DOCUMENT 00 90 00
ADDENDUM

ADDENDUM NO. [1]

Date: July 11, 2018

**RE: WISCONSIN INDIANHEAD TECHNICAL COLLEGE
WITC – BALSAM LAKE REGIONAL CENTER
INTERIOR REMODEL
HSR PROJECT NO. 17011**

A001R

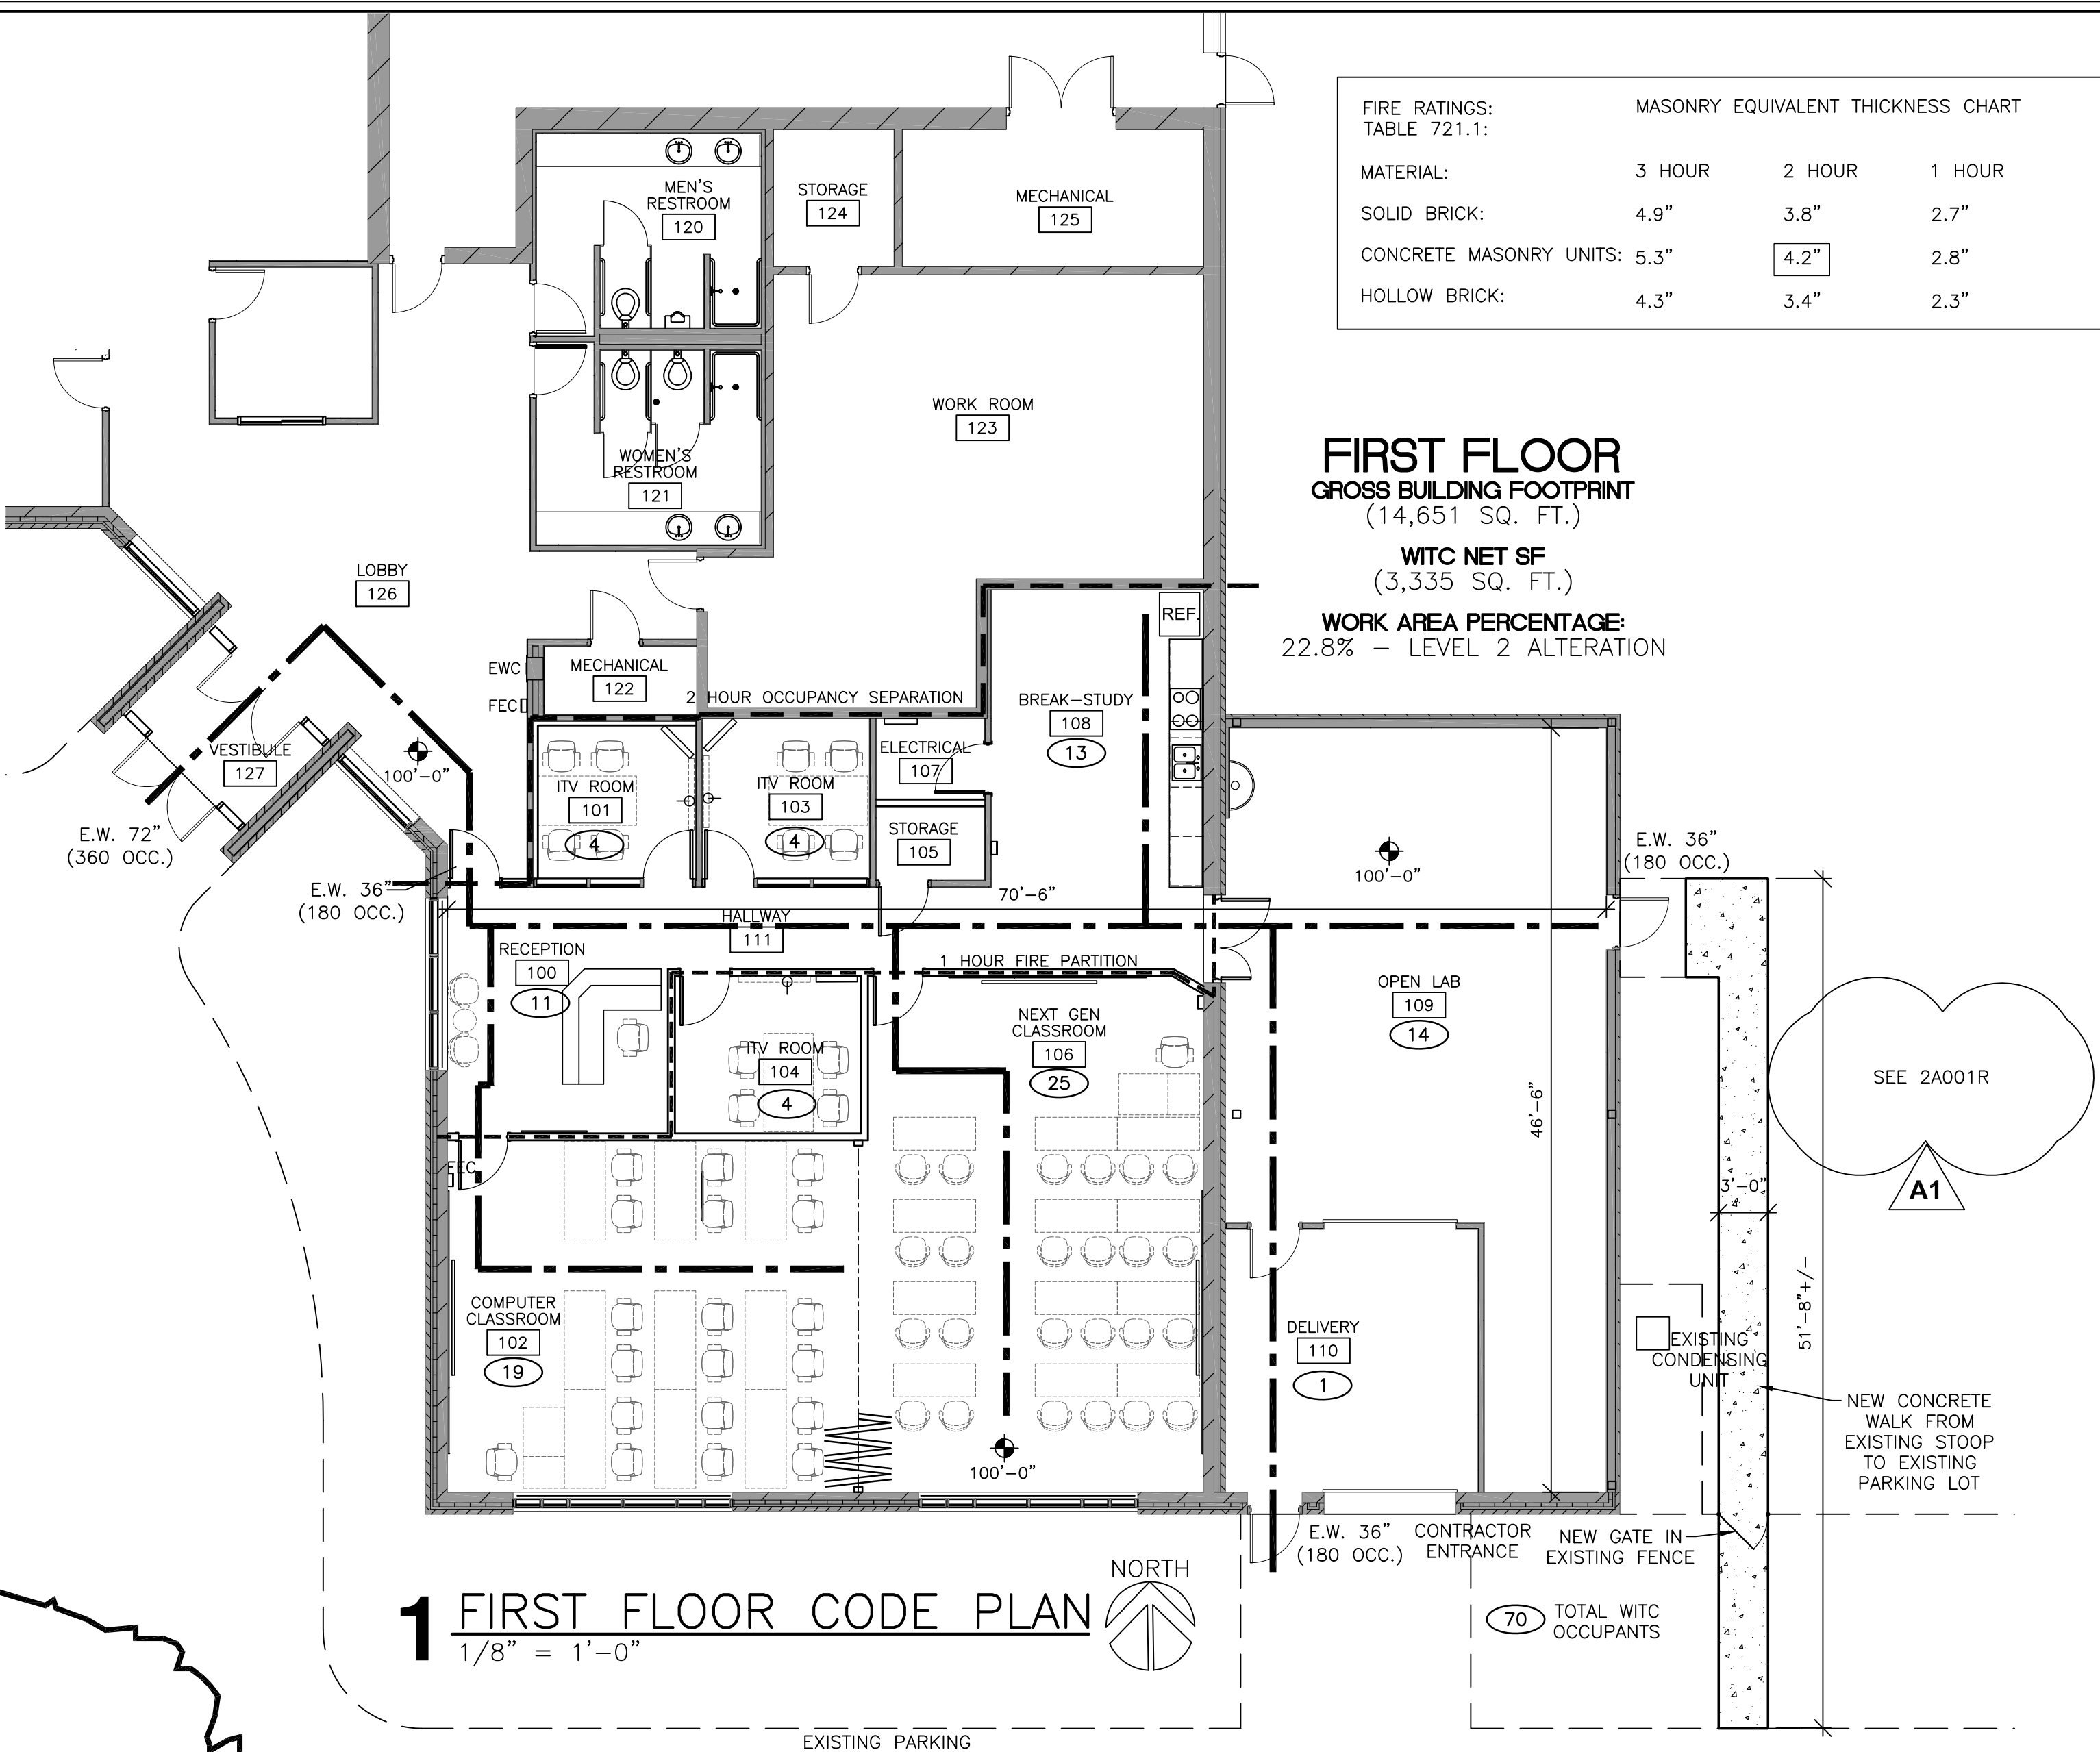
6. Sheet A001R COVER AND CODE SHEET 30 x 42 attached hereto
 - a. Revisions as noted in the attached drawings.
 - i. Edits to the exterior sidewalk and fence revisions

- ii. Designation of Contractor parking area.
7. Sheet A090R REMOVAL PLAN 30 x 42 attached hereto
 - a. Revisions as noted in the attached drawings.
 - i. Designation of Alternate Bid 2 area.

6 MOVABLE WALL HEAD
1 1/2" = 1'-0"

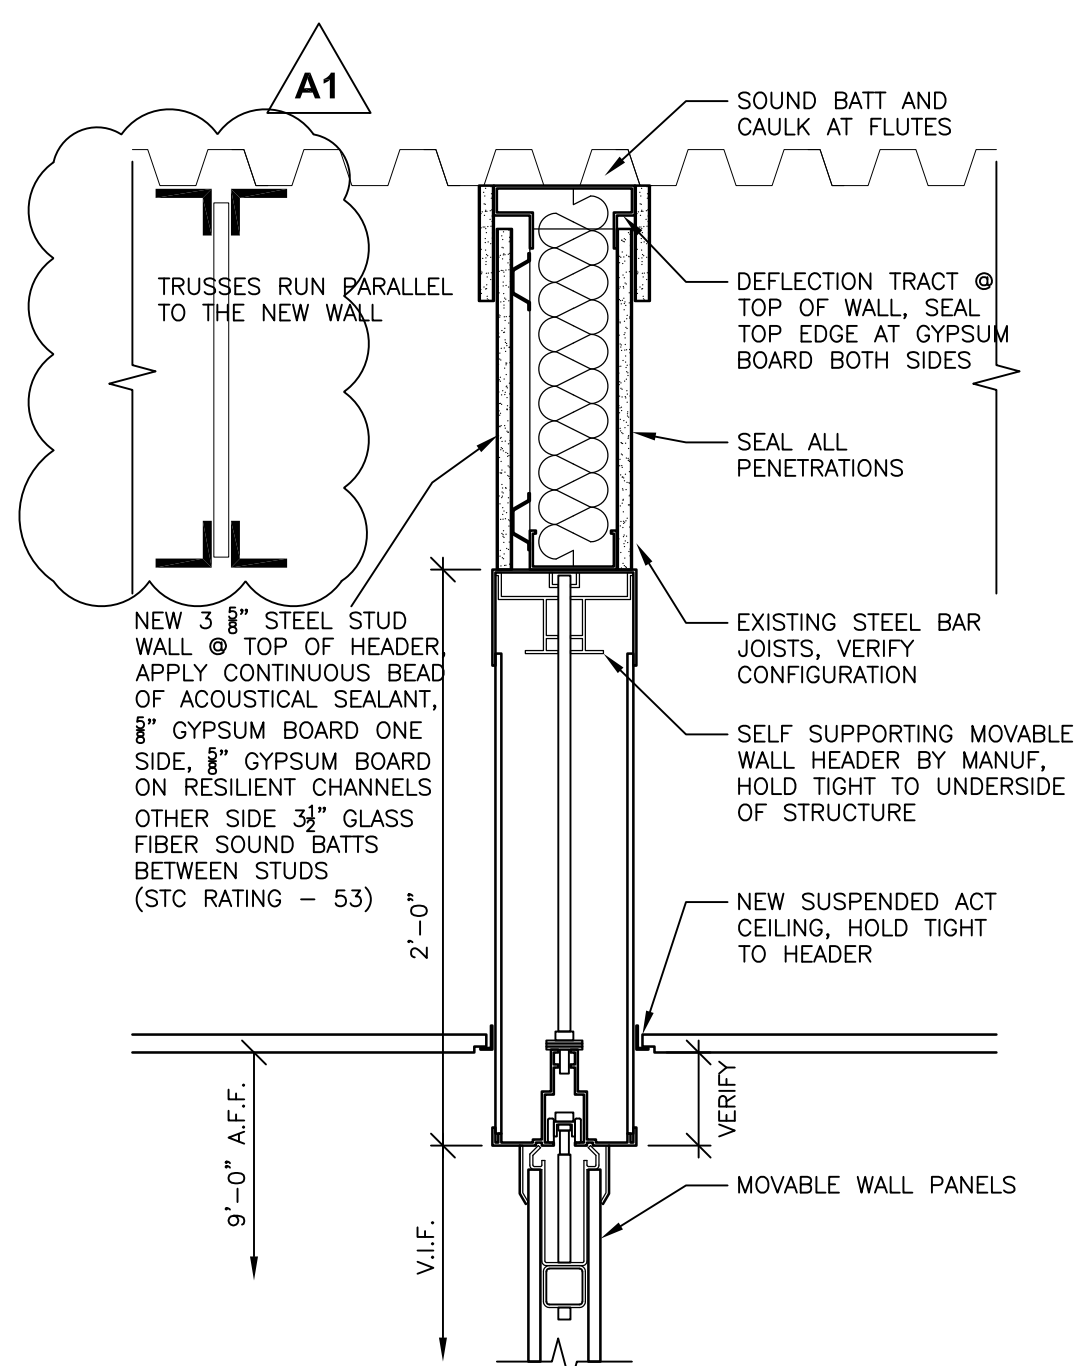
- ii. Detail 2: Revise countertop height. Add relocated dishwasher and revise casework.
 - iii. Detail 6: Notation of the actual truss direction.
9. Sheet A110 CEILING PLAN

1 FIRST FLOOR PLAN
1/4" = 1'-0"

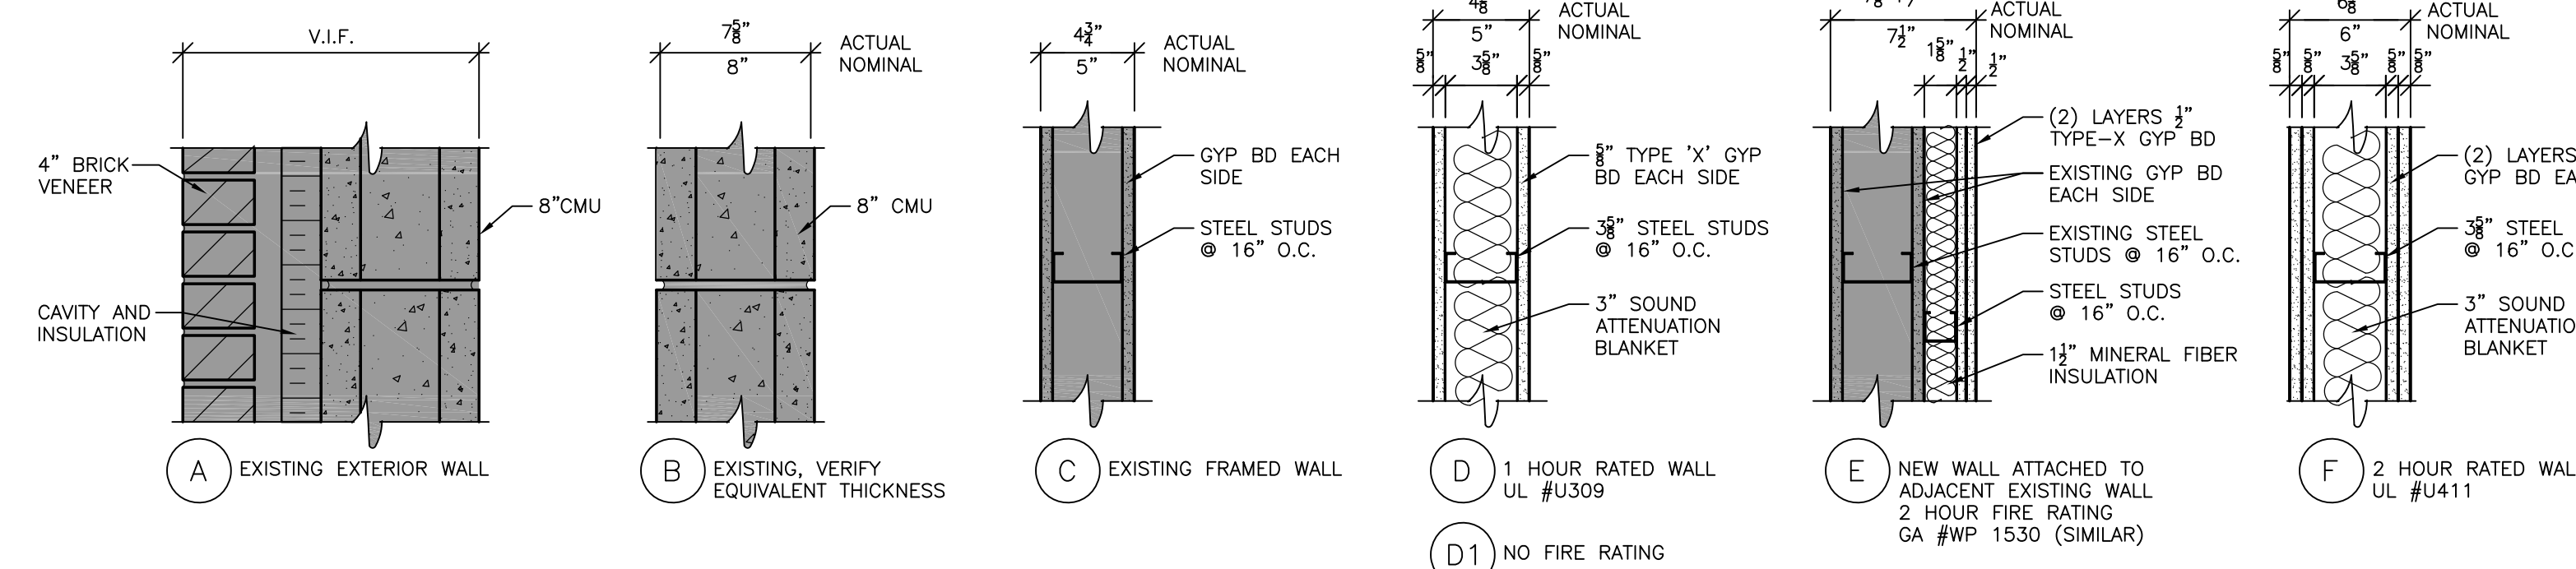
8. Sheet A100R FLOOR & CEILING PLANS 30 x 42 attached hereto
 - a. Revisions as noted in the attached drawings.
 - i. Detail 1: Designation of Alternate Bid items 2 and 3.

2 PLUMBING PLAN
1/8" = 1'-0"

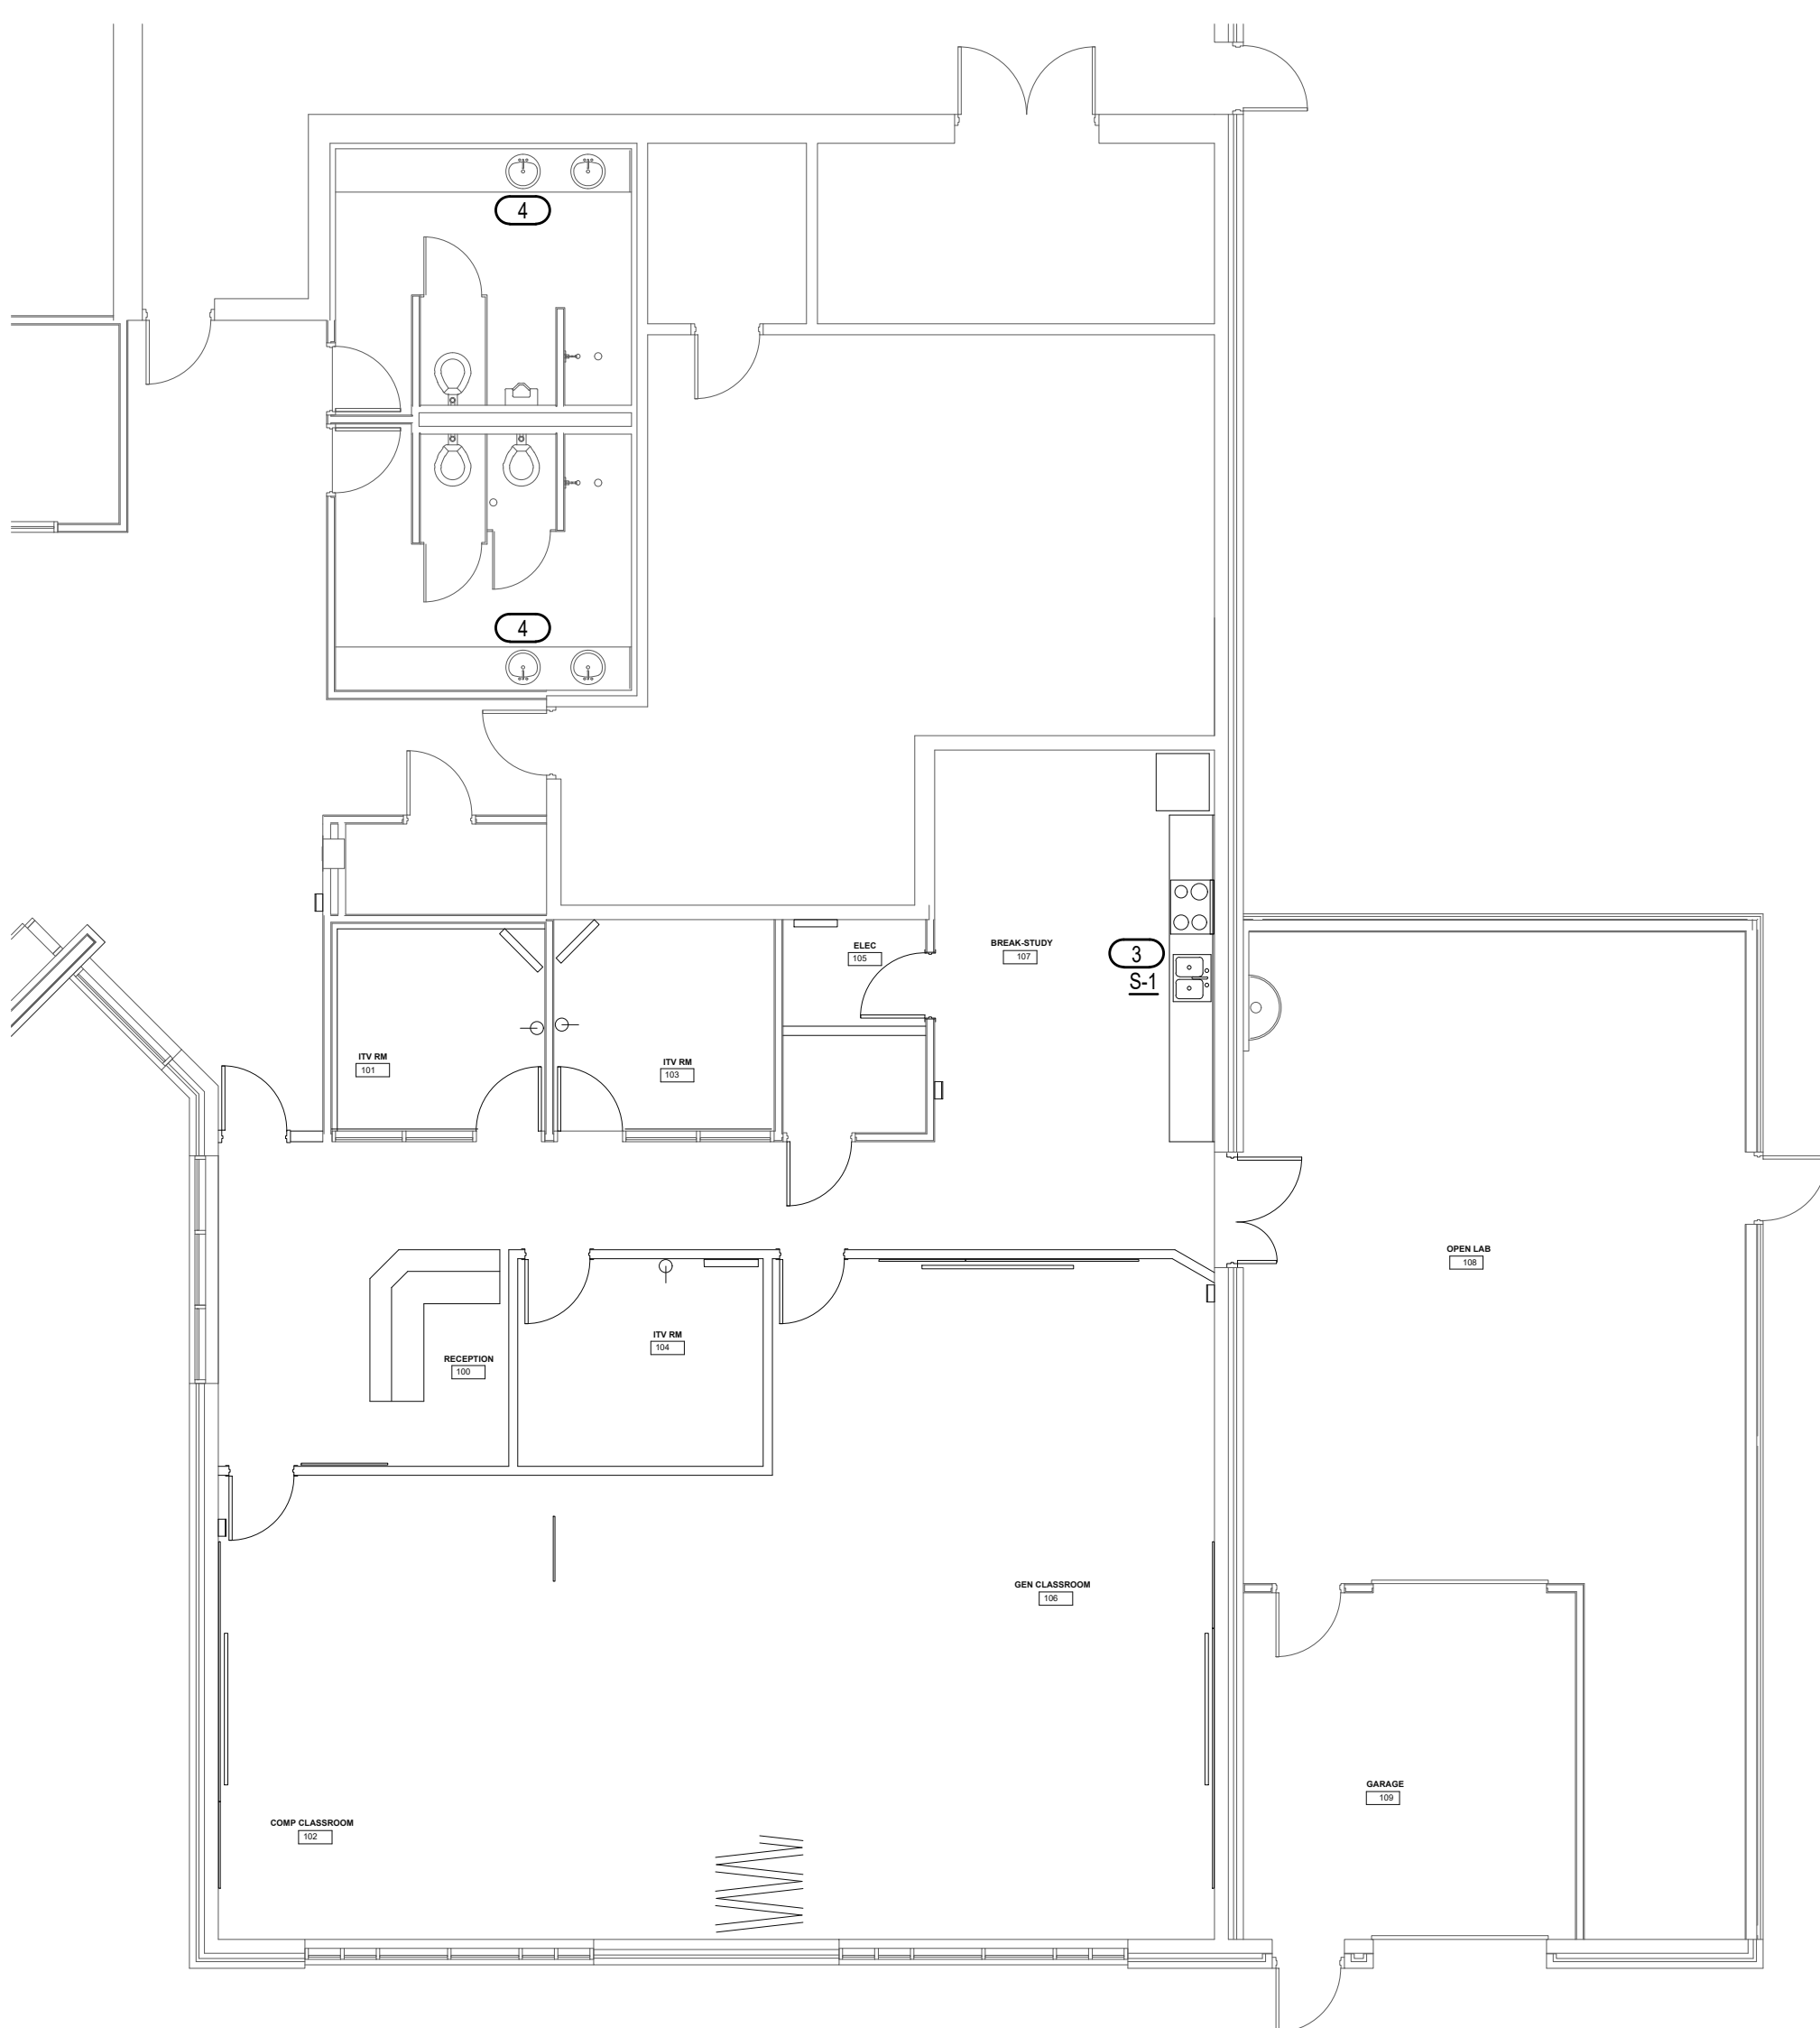
15. Sheet P101R PLUMBING PLANS 30 x 42 attached hereto

- a. Revisions as noted in the attached drawings.
 - i. Add dishwasher connections to S-1.

MARK	FIXTURE	MANUFACTURER	MODEL	MOUNT	ROUGH-IN SCHEDULE			FITTINGS AND REMARKS
					COLD	HOT	WASTE	
S-1	DOUBLE COMPARTMENT SINK	ELKAY	DLR-3322-3	COUNTER	1/2"	(2) 1/2"	(2) 1/2"	PROVIDE CHICAGO 786-GNBAE28VKKABCP FAUCET, MCGUIRE 8812 P-TRAP, MCGUIRE 151A STRAINER AND MCGUIRE H215SCCLX STOPS. PROVIDE ADDITIONAL HW AND SANITARY ROUGH IN TO SERVE DISHWASHER.
